**ACIS Verification Summary Report****Specification:**

AXAF Observatory to Science Instrument ICD (IF1-20)

3.5.3.2.1d SI Electronic Equipment Grounding (VRSD 3.5.3.2.1d)

Drawing Submittal

849AC 42000  
SHEET 2

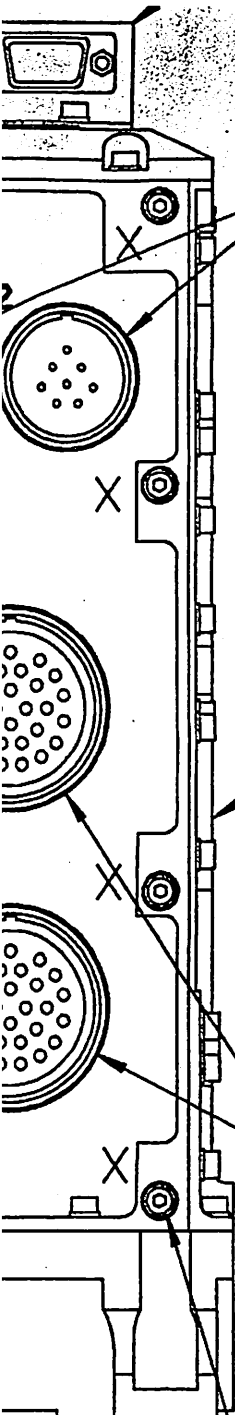
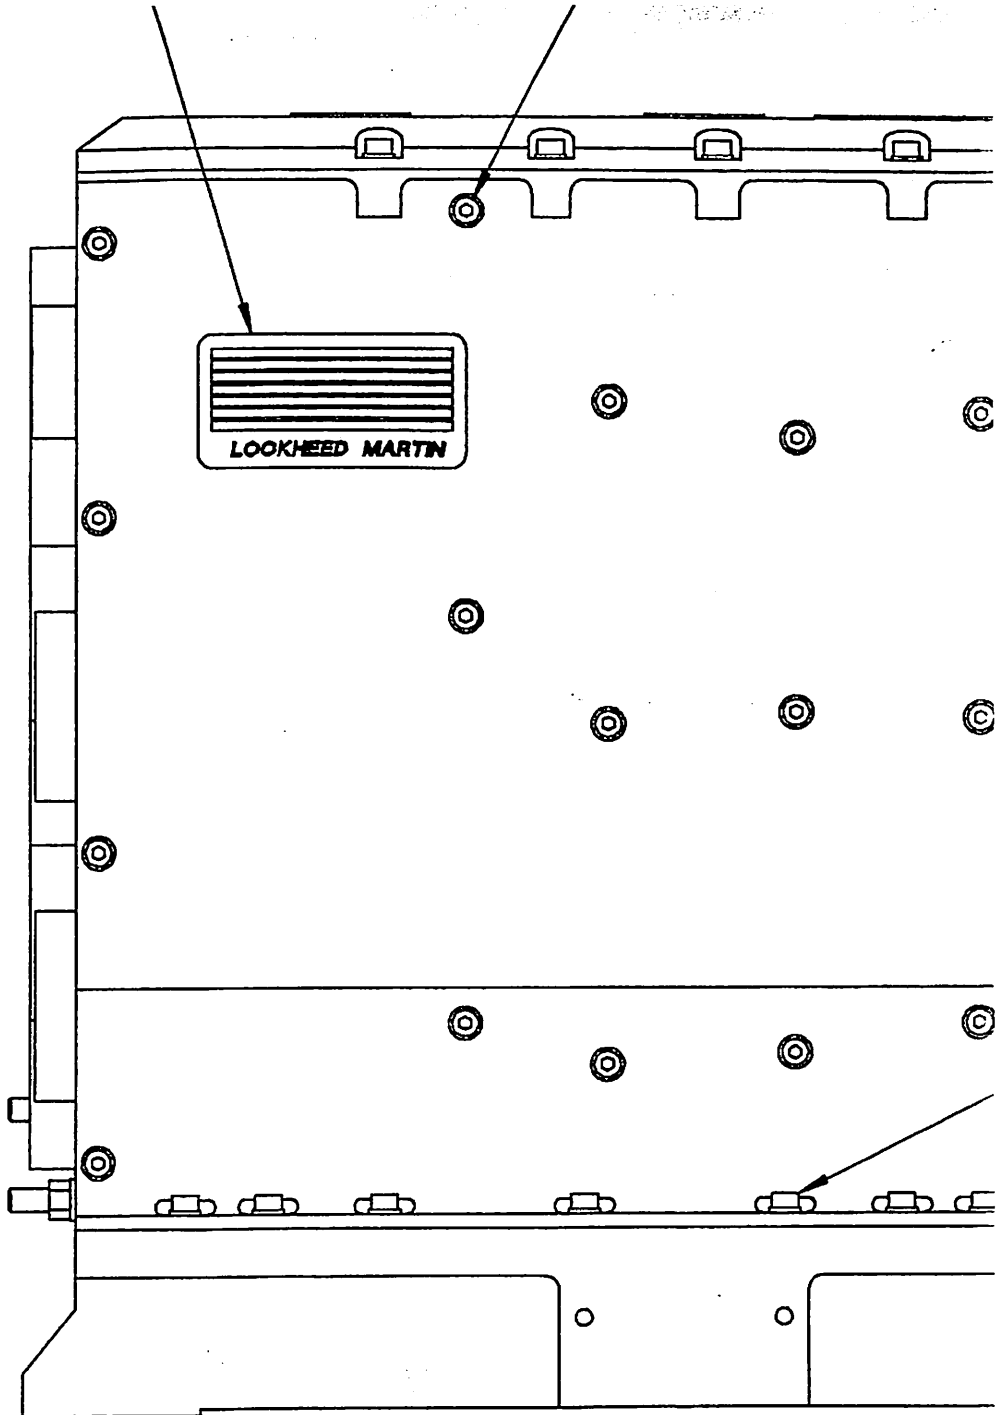
Attached is an excerpt from the Power Supply and Mechanism Controller Top Level Assembly Drawing 849AC420000, Sheet 2. The two ground lugs (either of which can be used as the primary or redundant return) are identified by the two arrows at detail "K". Submittal of this drawing provides closure for this requirement verification.

*2 gnd  
legs*
